From: Sara Roediger, AICP
Date: 2/9/2017
Re: **Beyond Self Storage**
Preliminary/Final Site Plan - Planning Review #2

From: Jason Boughton, AC, Engineering Utilities Coordinator
To: Sara Roediger, Manager of Planning
Date: February 7, 2017
Re: Beyond Self Storage, City File #16-036, Section #29
Site Plan Review #2

From: Mike Taunt, Survey Technician
To: Sara Roediger, Manager of Planning
Date: January 6, 2017
Re: Beyond Self Storage, City File # 16-036, Section 29
1st Review, New Site Plan

From: Craig McEwen, R. A., Building Inspector/Plan Reviewer *CPN*
To: Sara Roediger, Planning Department
Date: January 27, 2017
Re: Beyond Self Storage – Review #2
Sidwell: 15-29-276-011 & 013
City File: 16-036

CITY OF ROCHESTER HILLS STANDARD DETAIL FOR: Sight Distance Pathways					
DRAWN BY: B. SMITH	FILE NAME: CIRC DRV	PLAN DATE: 8/28/1996	REV. 4/12/2012	REV. 3/15/2014	REV.
APPROVED BY: PAUL SHUMEJKO, P.E., PTOE CITY TRANSPORTATION ENGINEER				NOT TO SCALE	
				SHEET 2 OF 2

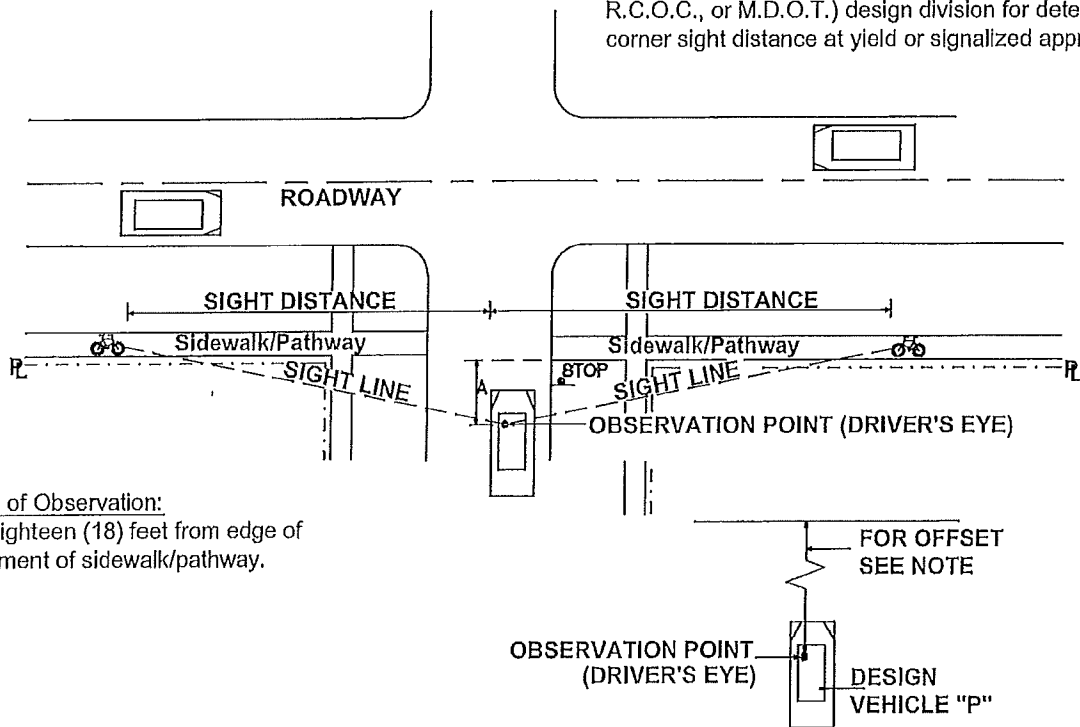
1. On sheet L-1.0, label "Pathway" on the provided sight distance lines and show the road sight distance lines per previously provided details.
